[Docket No. FAA-2012-0060; Directorate Identifier 2012-NE-02-AD; Amendment 39-17123; AD 2012-14-09]

Airworthiness Directives; Pratt & Whitney (P&W) Division Turbofan Engines

ACTION: Final rule.

Figure 1 to Paragraph (e) - Determination of Vane Eligibility

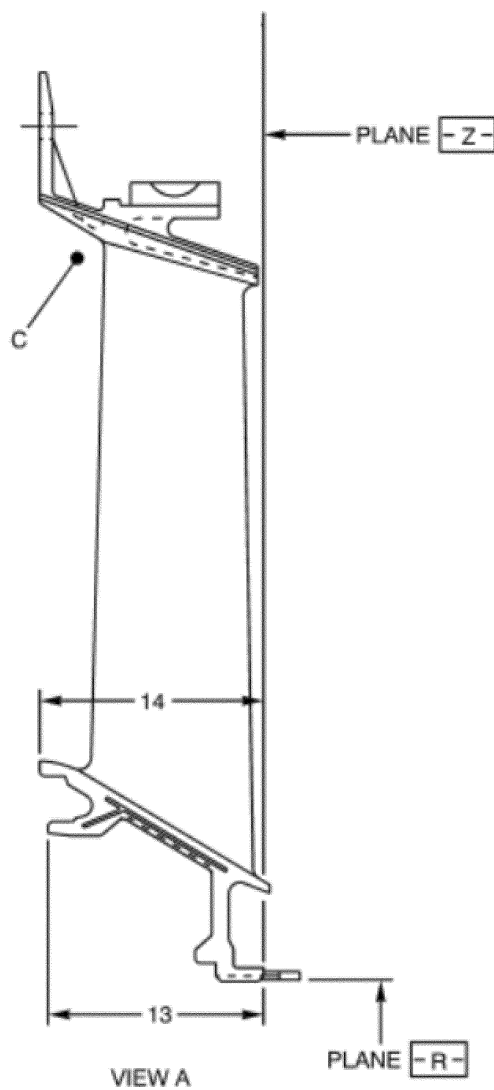
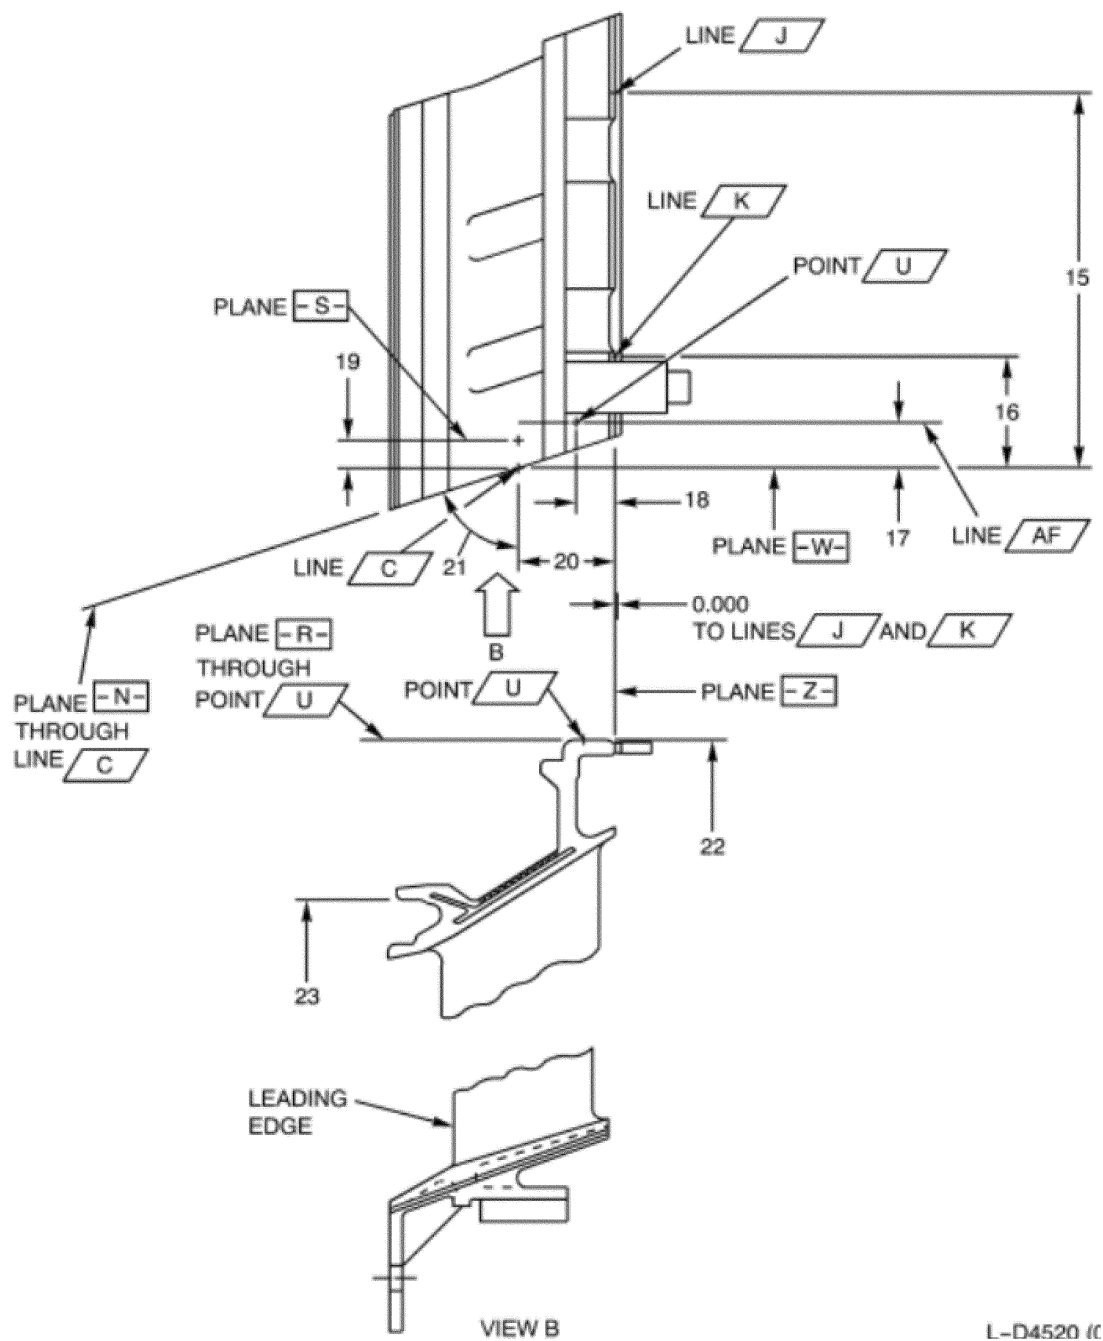
United Airlines requested that in proposed AD paragraphs (e)(1)(iii) and (e)(1)(iv), we change "ensure adequate engagement" to "dimensionally inspect the applicable LPT case slot serviceable dimensions and 3rd stage vane serviceable dimensions per the appropriate CIR." The commenter also requested that we list the specific dimensions to inspect by index number. The commenter stated that no mechanic can deduce what an adequate engagement is because it is not specific enough.

We agree. We changed paragraph (e)(1)(iii) to "dimensionally examine index 13 through index 34 of the LPT 3rd stage vane cluster assembly." We also changed paragraph (e)(1)(iv) to "dimensionally examine index 23 and index 24 of the vane engagement slots on the rear turbine case, where the 3rd stage vane is installed." We also listed the specific dimensions to inspect by index number, and included the supporting figures in this AD.

(iii) Dimensionally examine index 13 through index 34 of the LPT 3rd stage vane cluster assembly. Use Table 2 to paragraph (e) of this AD and Figure 1, Figure 2, and

Figure 3 to paragraph (e) of this AD to determine whether the vane is eligible for installation.

Figure 4 to Paragraph (e) - Determination of Case Eligibility

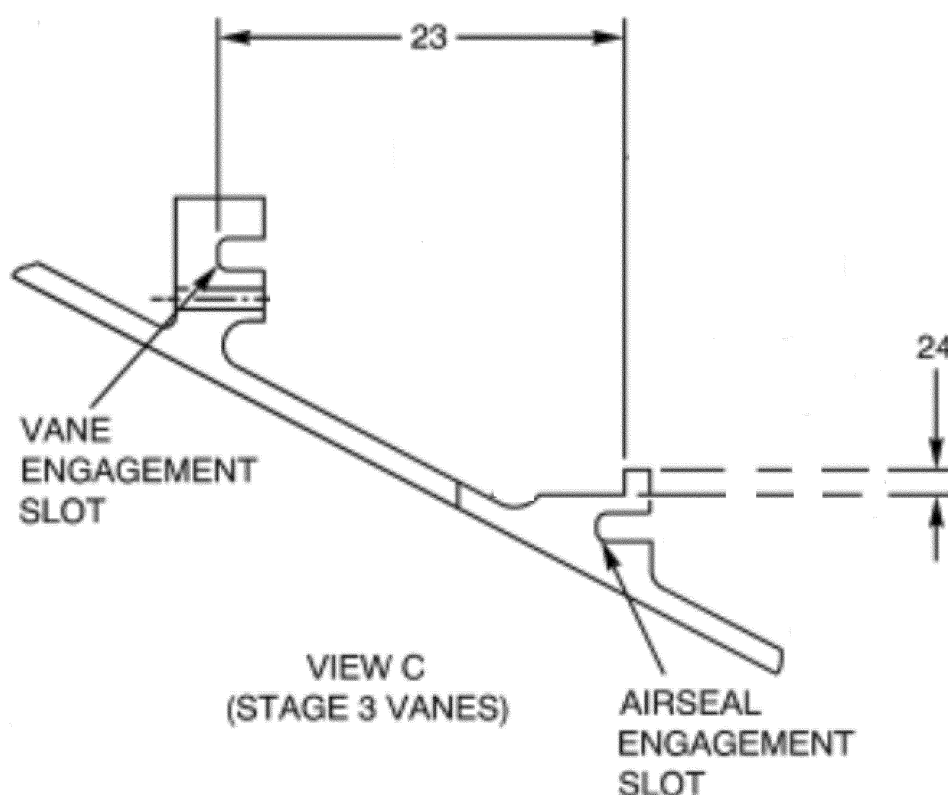
United Airlines requested that in proposed AD paragraph (e)(1)(iv) we make the CIR inspections more specific for the LPT case dimensions. The commenter stated that there are different ways to perform the measurements and it is not clear whether the dimension to measure is based on an average or an individual diametric dimension.

We do not agree. A specific measurement technique is not defined because multiple measurement techniques exist that are acceptable. The only diametric dimensional inspection required by the AD is index 24, which would be acceptable to measure based

on an average dimension. We did not change the AD.

(iv) Dimensionally examine index 23 and index 24 of the vane engagement slots on the rear turbine case, where the 3rd stage vane is installed. Use Table 3 to paragraph (e) of this AD and Figure 4 to paragraph (e) of this AD to determine whether the case is eligible for installation.
